DART SERVICE BULLETIN SB12-1

**D350-607-441/-443/-445/-447/-541/-543/-545/-547 HELI-UTILITY-BASKET
INSTALLATIONS AT CHANGE 003 OR EARLIER**

REF TCCA STC: SH94-14
FAA STC: SR00213NY
REF EASA STC: 10016996
REF ANAC STC'S: 2007S03-03/-04/-05/-06

AFFECTING:

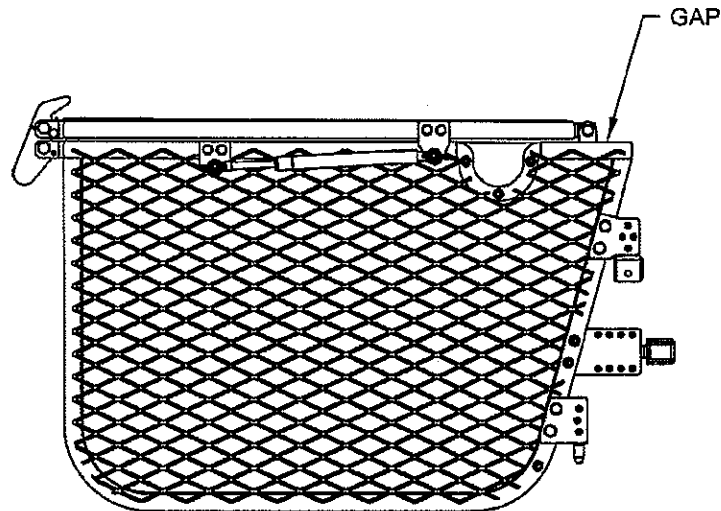
Dart Aerospace Ltd. has received information indicating that under certain circumstances on **D350-607-441/-443/-445/-447/-541/-543/-545/-547** Heli-Utility-Basket Installations at **CHANGE 003 or earlier**, thin flexible objects such as an unsecured retaining strap can find their way out of the basket through the narrow opening located along the top inboard side of the basket base assembly and cause damage to the aircraft and/or depart from the basket in flight.

For operators with aircraft equipped with **D350-607-441/-443/-445/-447/-541/-543/-545/-547** Heli-Utility-Basket Installations at **CHANGE 003 or earlier** it is recommended that the opening described above be closed off with D4672-X Blanking Plates using the DSI 9618-011 Blanking Plate Kit (for D350-607-441/-443/-541/-543 Heli-Utility-Basket, Long) and DSI 9618-013 Blanking Plate Kit (for D350-607-445/-447/-545/-547 Heli-Utility-Basket, Short) per **DSI 9618 Rev. A** (or later approved revision).
